ENVIRONMENTAL SCOPING REPORT

SAN RAFAEL TRANSIT CENTER REPLACEMENT PROJECT

February 2019

Figure 2
Two-Story Concept

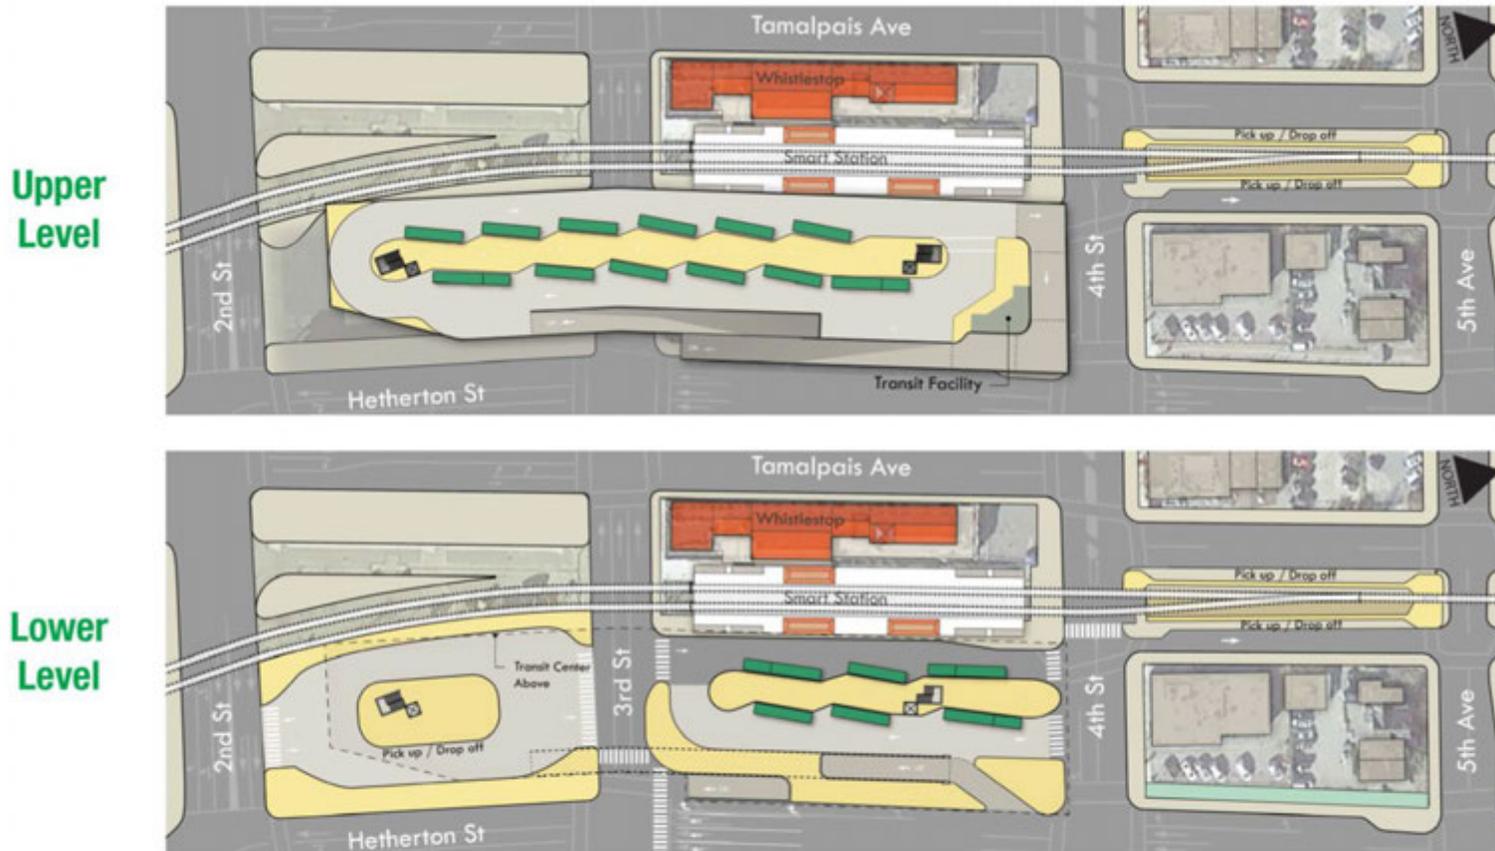
Two-Story Concept Alternative

- Asks to consider impacts of vertical transit center on ADA accessibility and safety for transferring passengers; stairs present difficulty in transferring for those with mobility issues.
- Asks to consider visual impacts of crossing at 3rd Street.
- Asks to consider danger of passengers making transfers across busy streets.
- Raises concerns regarding cost of a structure that would co-locate all 17 bus bays off-street to meet current and future needs.
- Raises concerns about aesthetics of building; two-story design may be visually intrusive.
- Raises concerns about cost of this alternative.
- Asks to consider utilizing the undisturbed portion of Bettini for additional bus bays.

- Requests that additional trees be planted and more color be added for atmosphere.
- Requests consideration of the aesthetic impacts of the unused portion of the Bettini property under the Two-Story alternative.

Figure 3
Across the Freeway Concept

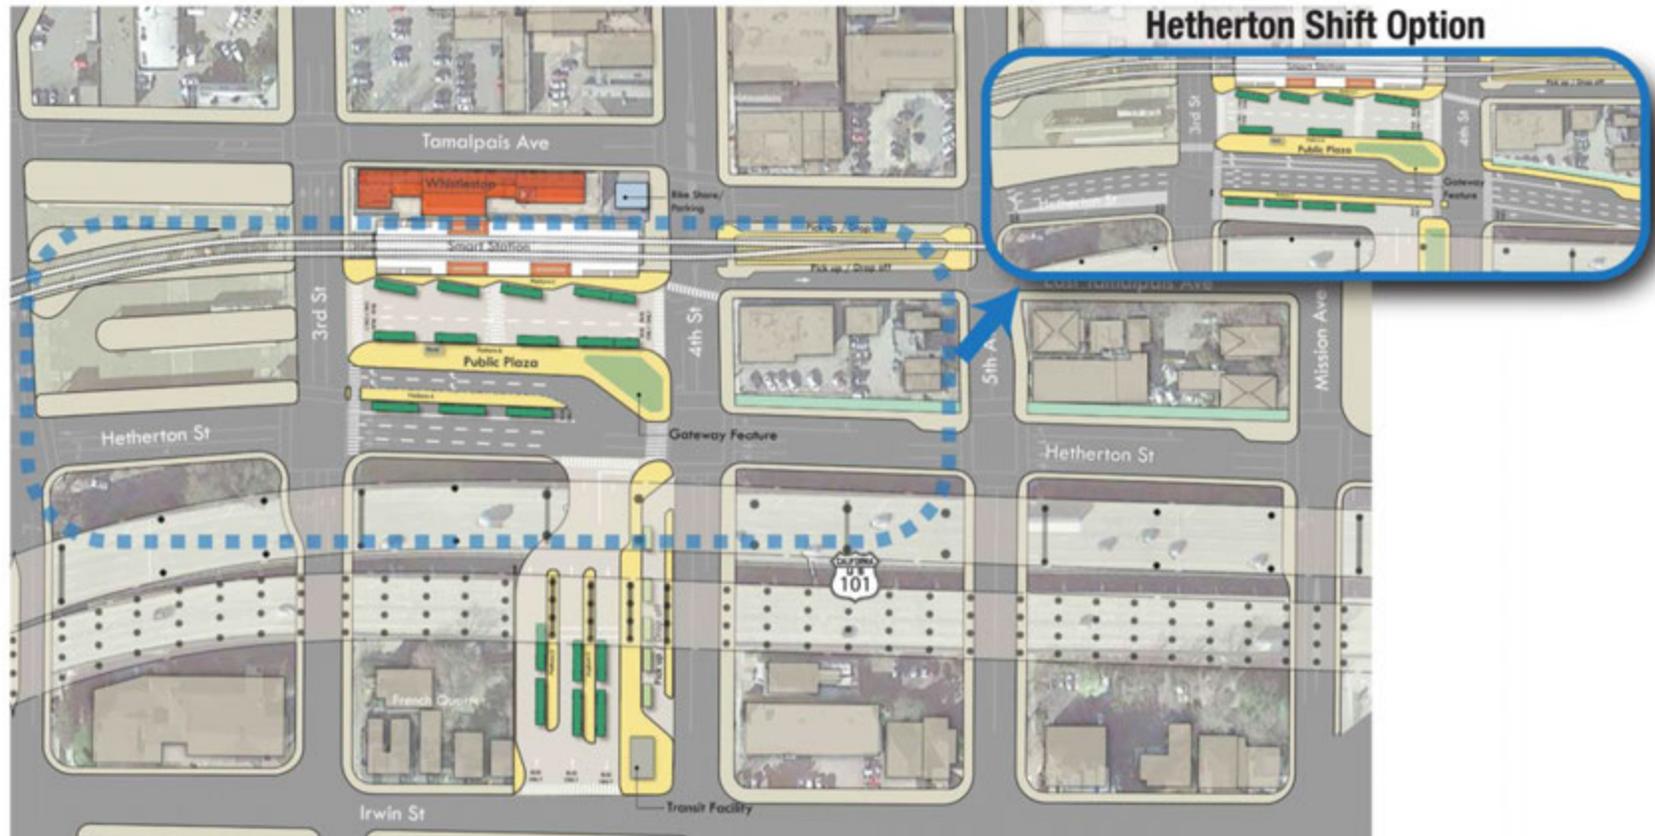
Across-the-Freeway Concept Alternative

- Asks to consider lack of natural light and tunnel effect below structure.
- Offers support for this alternatives as improving a visually blighted area.
- Raises concerns about undesirability of walking across Hetherton Street under freeway.
- Raises concerns about the crossing providing difficulty for those with limited mobility.
- Raises concerns about long walks between transfers.

Figure 5
Whistlestop Block Concept

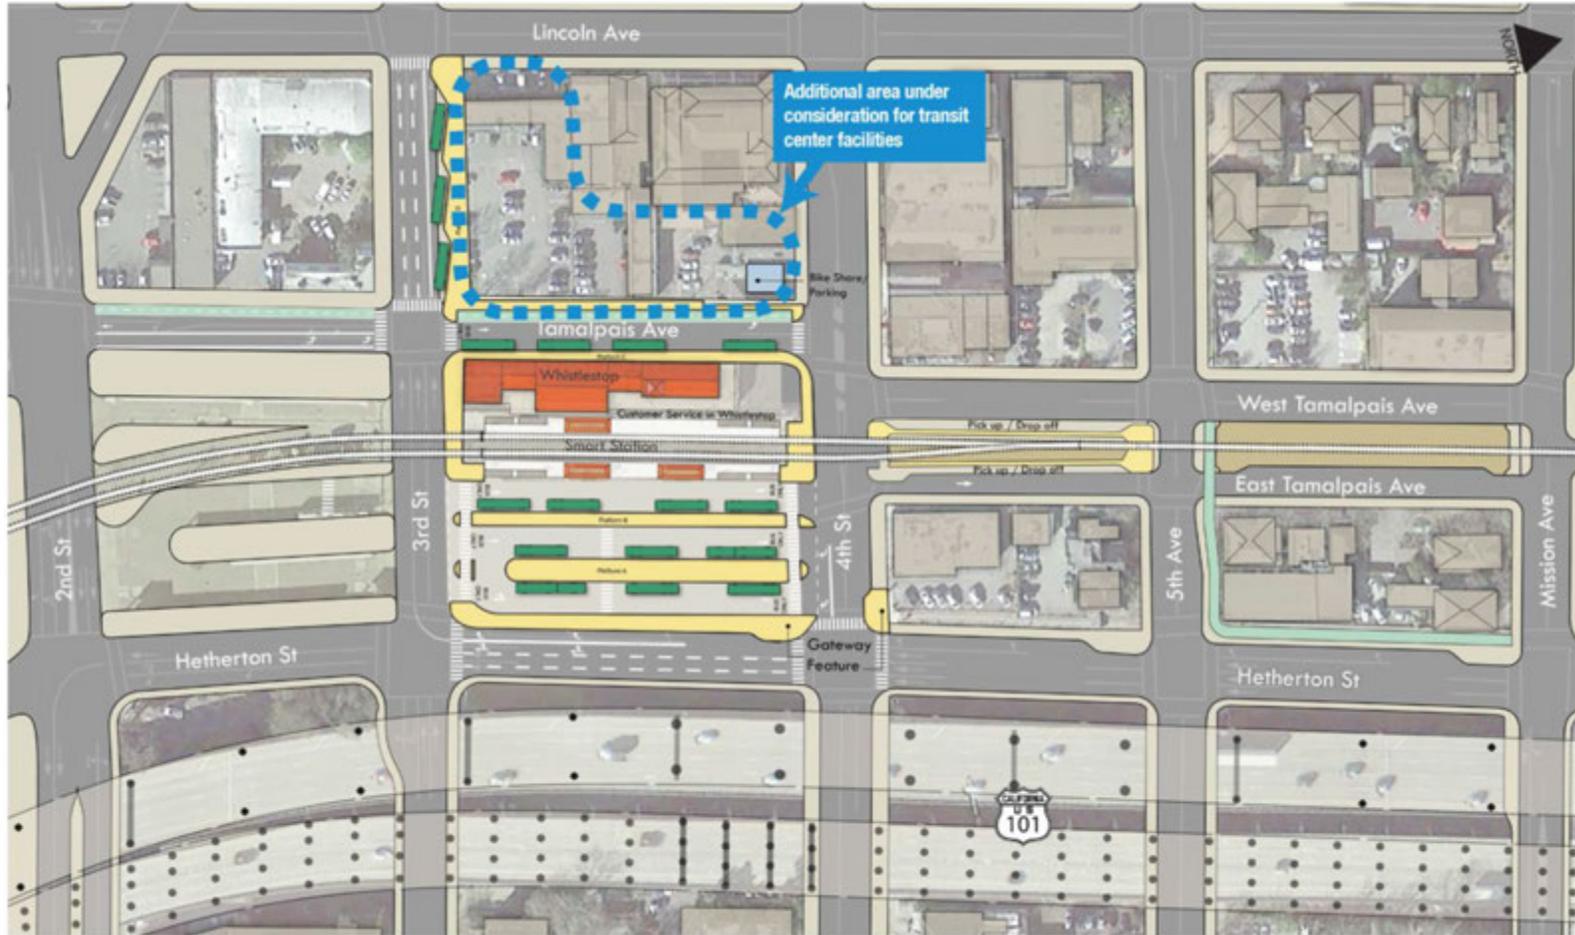
Whistlestop Block Concept Alternative

- Expresses preference for the Whistlestop Block Concept and requests that it be modified so riders could transfer between bus and train without crossing streets.

- Requests the addition of four bus stops on Hetherton Street and three on opposite side of the platform.
- Requests more space to accommodate additional stops and to allow for buses traveling east on 4th Street to turn more easily onto Hetherton.

- Requests moving three bus bays on 3rd Street and four bus bays on Tamalpais Avenue to the area now used for Whistlestop parking lot at Tamalpais and Lincoln.

- Requests that Tamalpais Avenue between 3rd Street and 4th Street be designated as a passenger drop off and pick up area.
- Requests illustration of internal vehicle circulation patterns to access all properties within the block.

- Raises concerns about bus bays on 3rd Street because of negative impact on traffic and pedestrians near Lincoln Ave.
- Raises concerns about alternative resulting in additional congestion.

- Requests that the Whistlestop Building be an attractive center with shops and cafes.
- Requests bus ticketing facilities in the building.
- Requests closing Tamalpais Avenue between 3rd Street and 4th Street to create a bicycle and pedestrian boulevard/public plaza.

- Raises concerns about the extremely narrow sidewalk on Tamalpais and public safety as exiting passengers use this sidewalk.
- Raises concerns about the relocation of historic San Rafael Depot building.

- Requests reversing the direction of the four buses on Tamalpais so they enter from 4th Street and proceed south.
- Raises concerns that preserving the Whistlestop building leaves it as “an ungainly island” in the middle of the transit center.
